File Number: SSD 7610  
Our Ref: R/2016/15/A

### Development Application for the Inner Sydney High School (SSD 7610)

## ATTACHMENT A

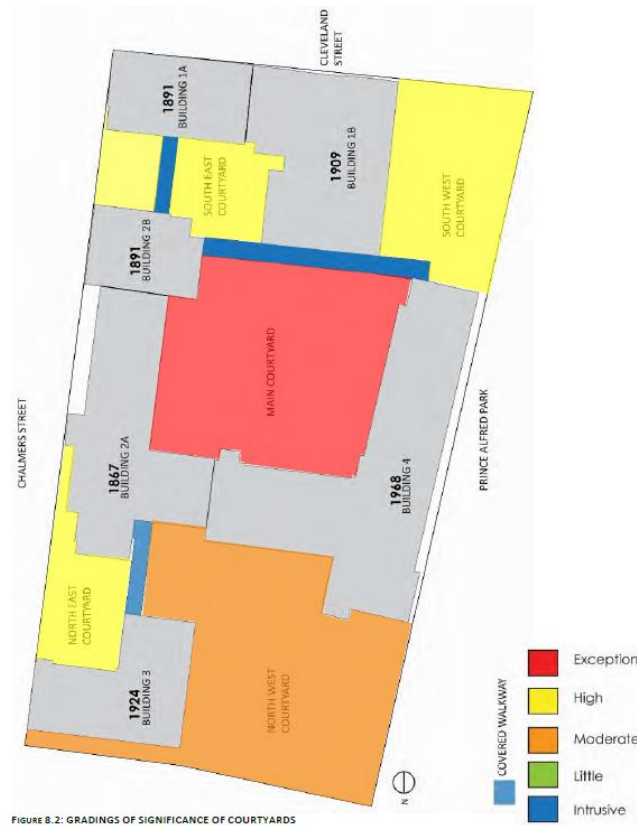
The proposed erection of the 14 storey building in the school will impact on the setting of the park. The visual impact is caused by both the height and bulk. The new building will be the only high rise adjoining the park. From most vantage points

in the park, the tall building will appear on top of the surrounding trees. While, the building is not conspicuous from the northern section of the park, it is highly visible from the southern part, in particular the land on the southern side of the swimming pool. The visual dominance of the new building becomes apparent on the south-east corner of the park, south of the pool and east of mature trees running along north-south, as shown below. The visual impact on the “thoroughfare” of the park, the main path running north-south along the sport courts, appears acceptable, although this is reliant on the ongoing existence of the mature trees in the park.

**Major visual impact: red line area—the park area where major impact may be perceived; Blue line—affected streetscape**

A slender and simpler form of the tower, along with a decrease of the storeys at the podium, would reduce its visual impact to the setting of the park. While the

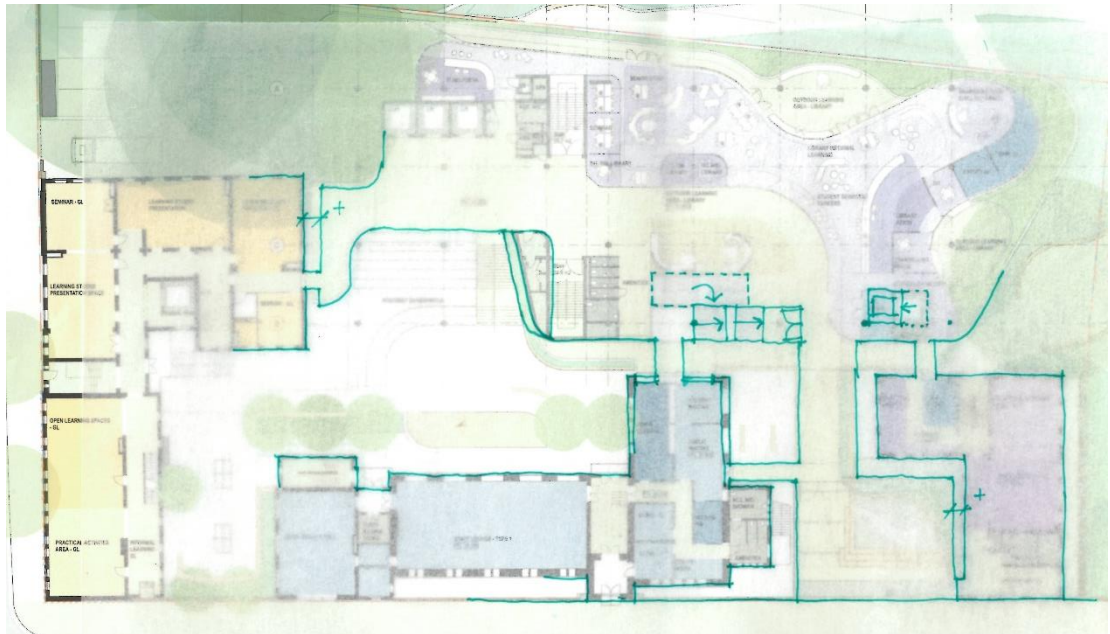
- The school's café and eating area is at Level 1. The space is almost fully covered by the level above, though is not enclosed at the sides. The elevations appear to show a partial glazed screen at the perimeter, though detail is not provided to describe the height, extent or to confirm adequacy.
- Therefore, additional information should be provided to confirm the amenity of the level 1 terrace in adverse weather. There does not appear to be an alternative internal area which provides adequate space for any proportion of students at lunch time.
